Warranty Bulletin

WB25-80

HYDRAULIC FAN SENSOR HARNESS RELOCATION 9700 (B13R)

On the vehicles affected by this bulletin, reroute the engine cooling fan speed sensor harness to avoid damage.

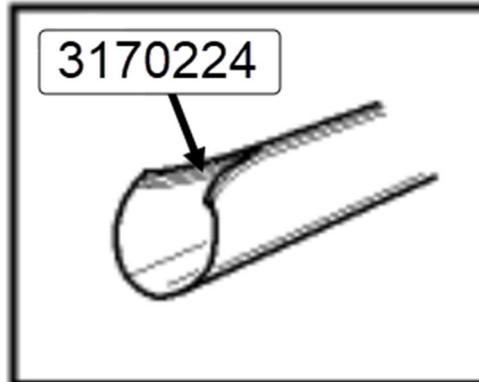
- 3) Cut cable-ties and remove the harness from its routing below the lower intercooler connection.

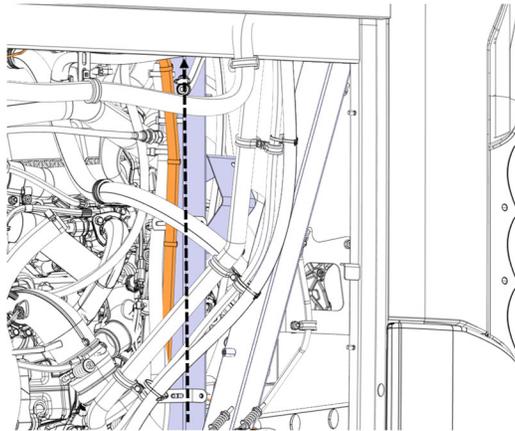
- 4) Inspect the harness branch for damage caused by contact wear. If the harness is damaged, repair it as necessary by cutting away the damaged section, and soldering or splicing the wires together to restore continuity.
- 5) Install zipper tube 3170224 over the sensor harness to protect it.

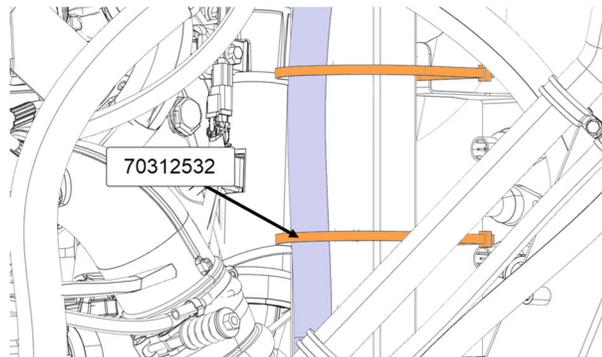
- 6) Reroute the electrical harness over to the left-hand side vertical structure fence element of the chassis.

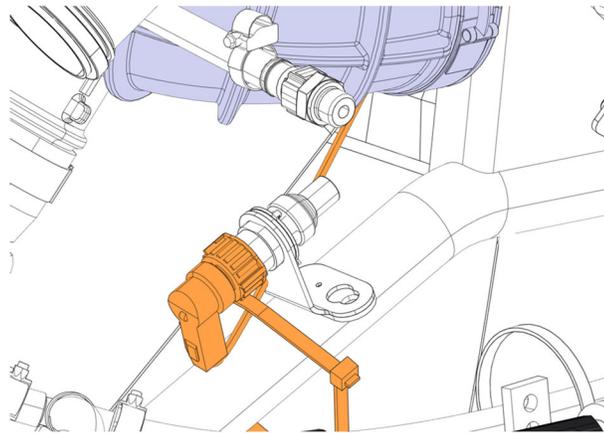
- 7) Use new cable ties 70312532 to secure the sensor harness along its new routing.
